SADDLE ROAD - WEST SIDE

HI A-AD 6(6) CULVERT PLAN AND PROFILE STATION 253+06

SADDLE ROAD - WEST SIDE
HI A-AD 6(6)
CULVERT PLAN AND PROFILE
STATION 253+06

SADDLE ROAD - WEST SIDE
HI A-AD 6(6)
CULVERT PLAN AND PROFILE
STATION 435+33

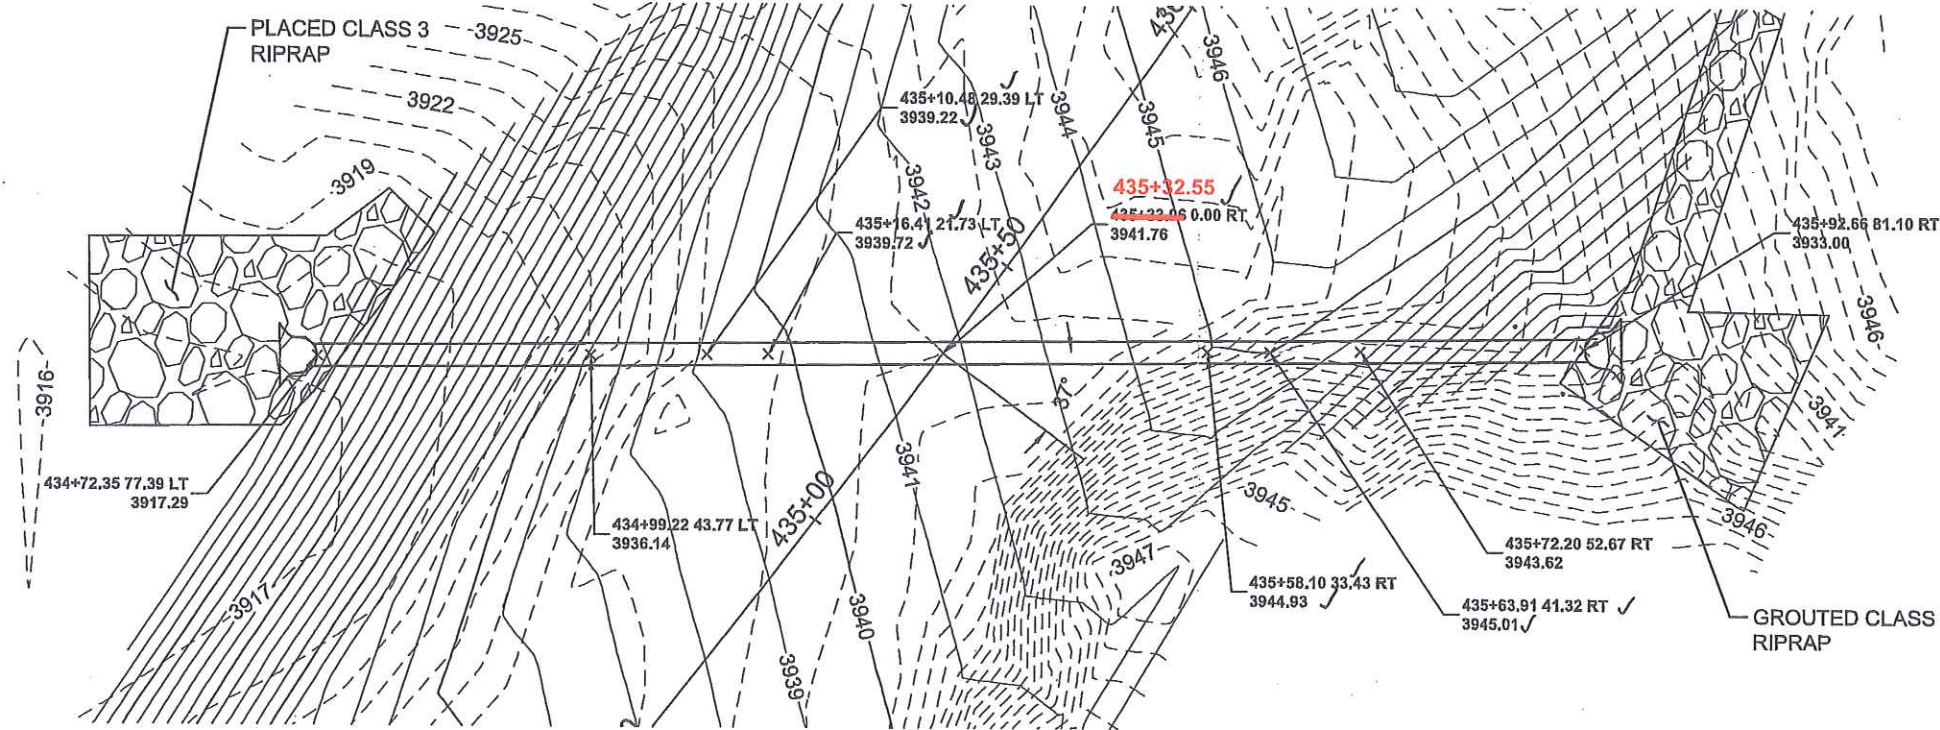
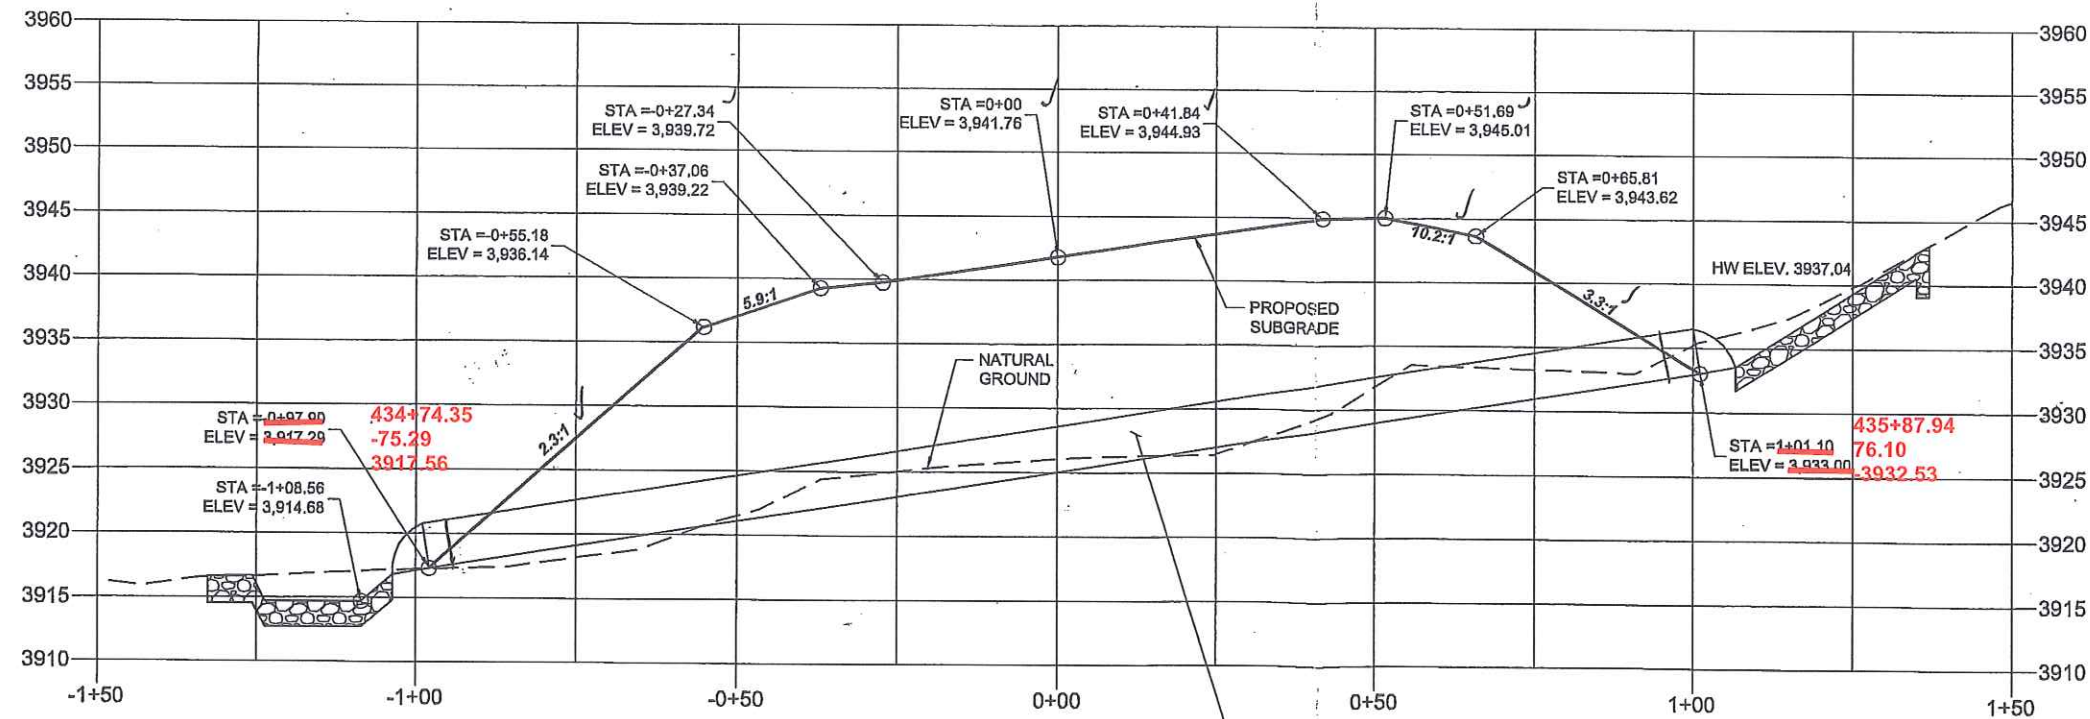
Outlet
Sta 0+93.9
Elev ~~3917.29~~

Inlet
Sta. 0+95.5
Elev = ~~3917.29~~

Approved as noted

SADDLE ROAD - WEST SIDE
HI A-AD 6(6)
CULVERT PLAN AND PROFILE
STATION 783+85

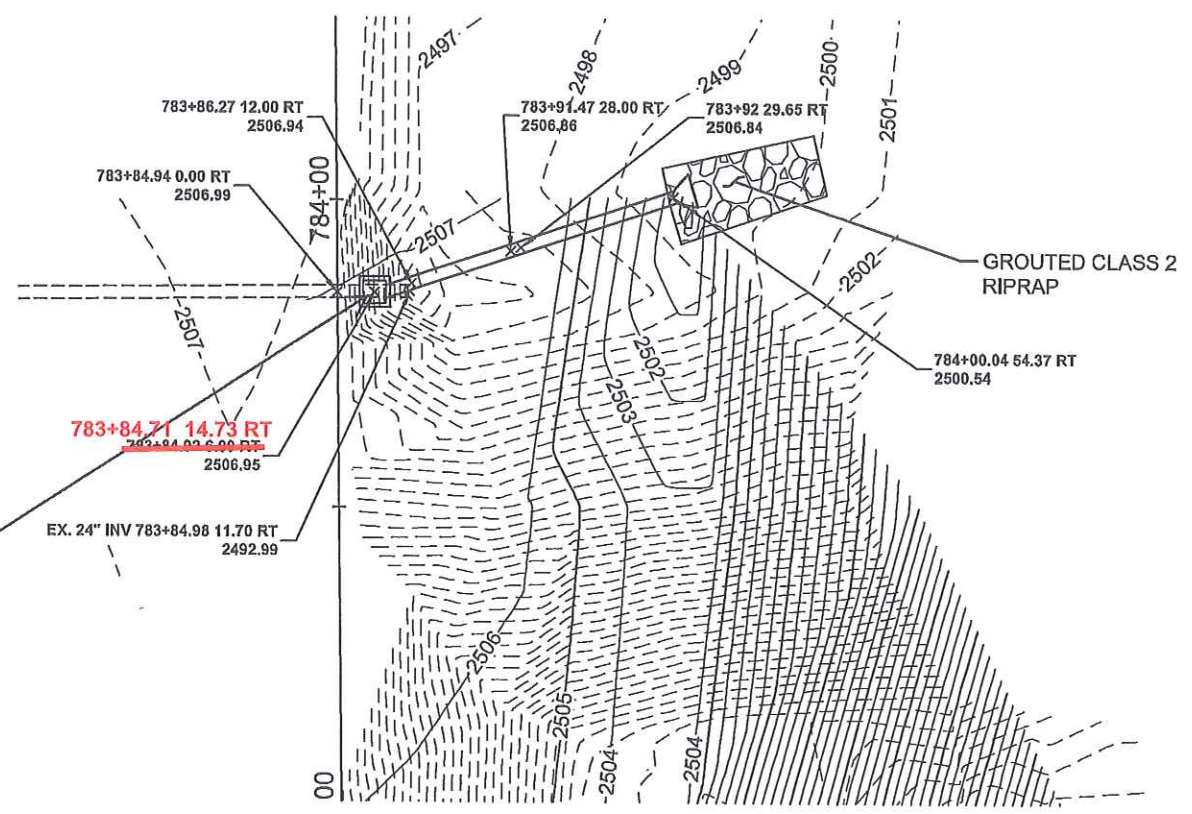
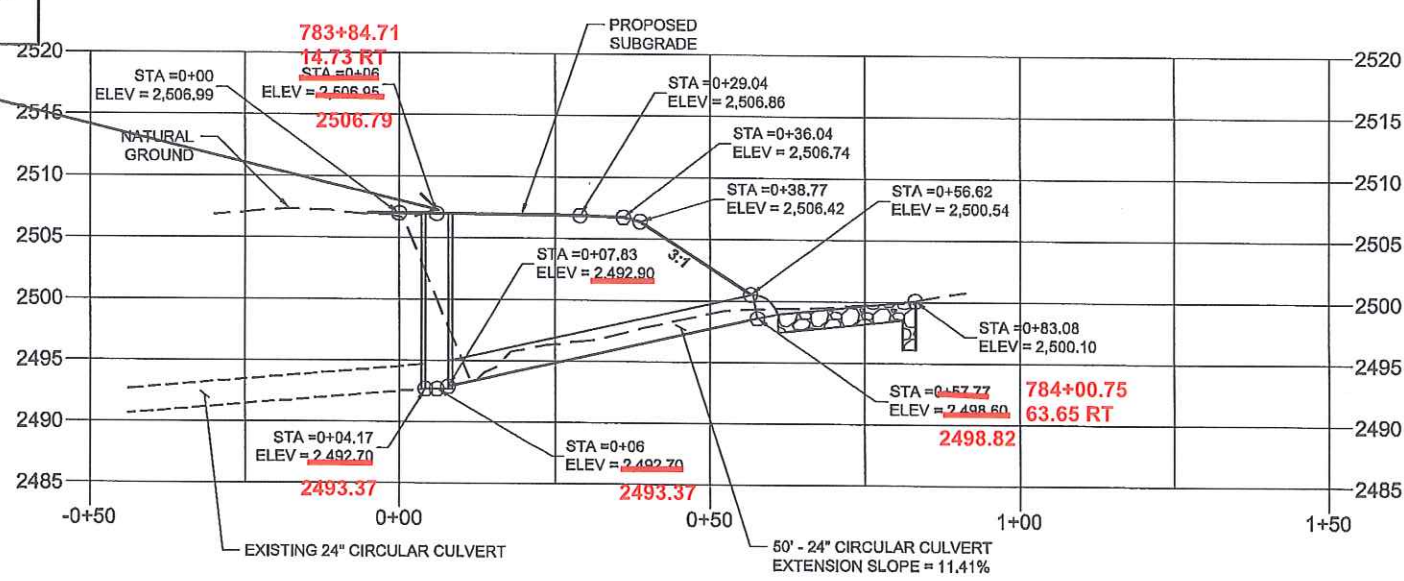
2506.79
Top manhole elev. = ~~2506.00~~. Adjust on 6(7) project.

2506.79
Top manhole elev. = ~~2506.00~~. Adjust on 6(7) project.

Approved as
noted, MHL
03/15/2012

SADDLE ROAD - WEST SIDE
HI A-AD 6(6)
CULVERT PLAN AND PROFILE
STATION 61+10

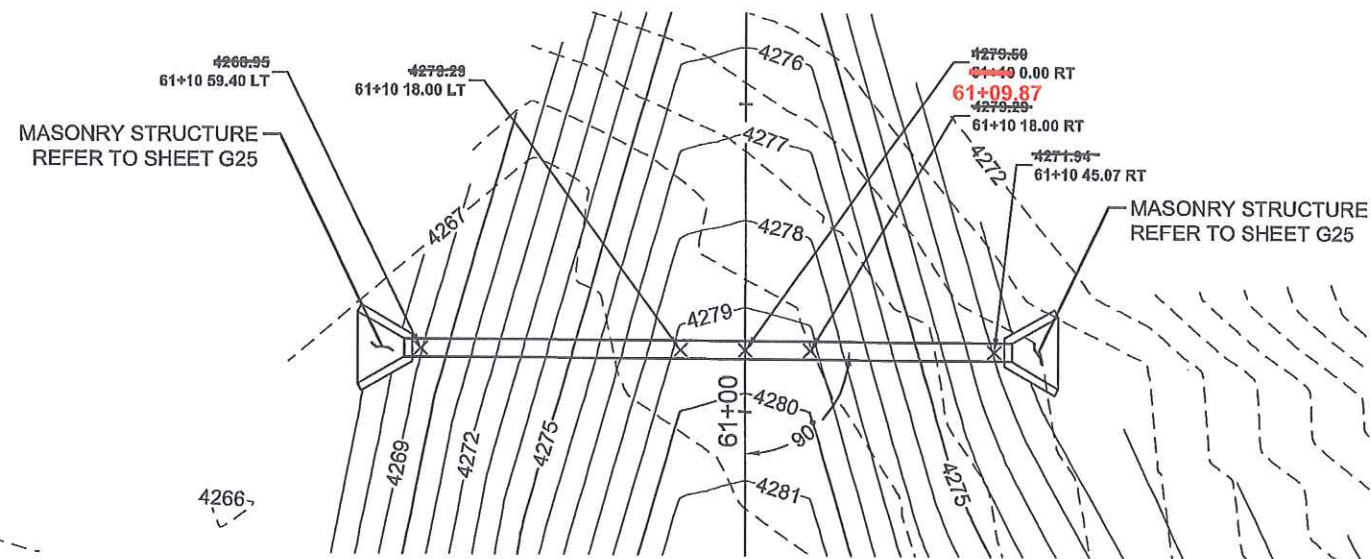
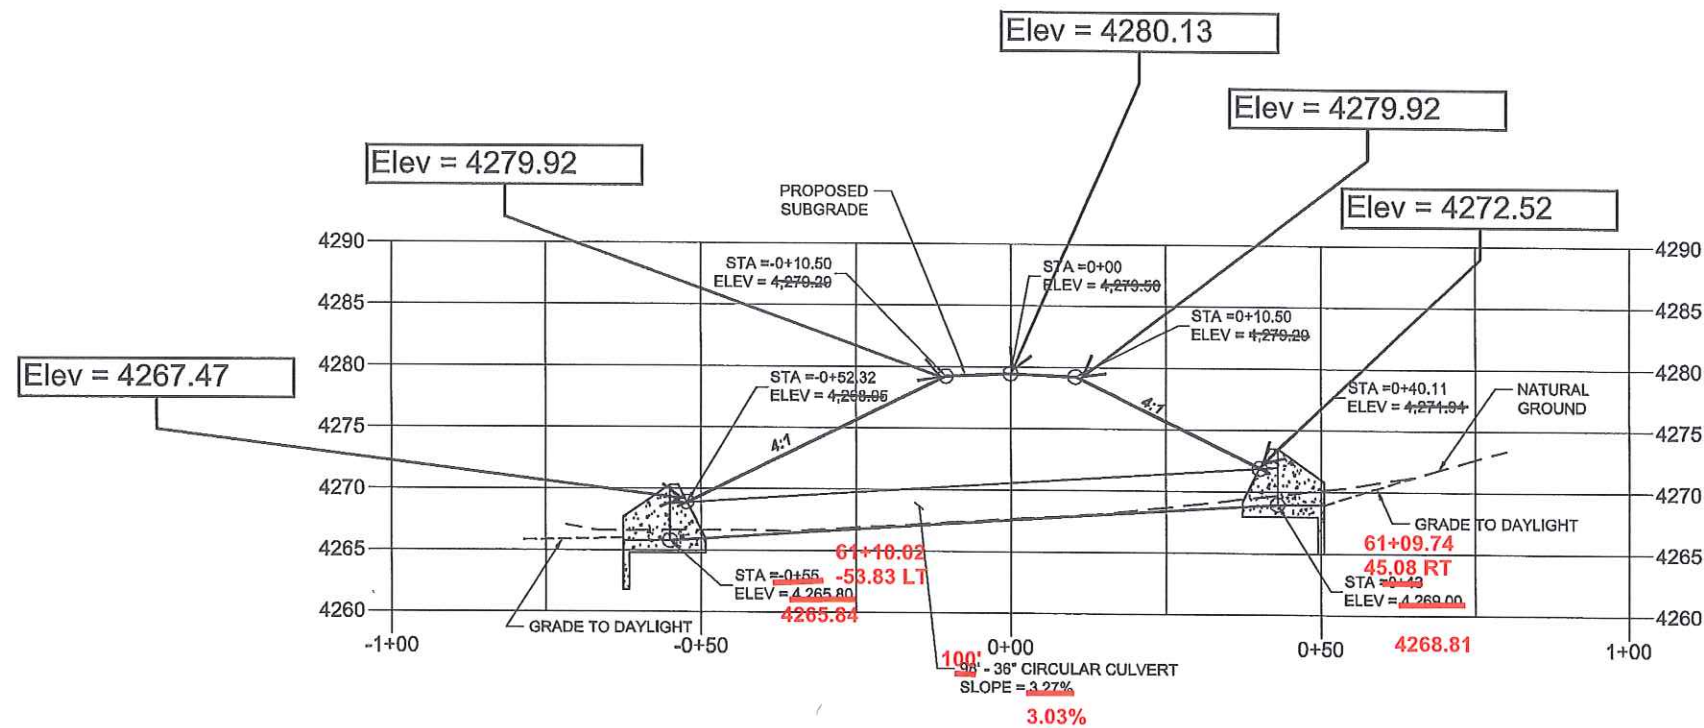
Received 03/23/2012 MHL
Approved as noted 03/23/2012 MHL
Approach Road Elevations are to subgrade.
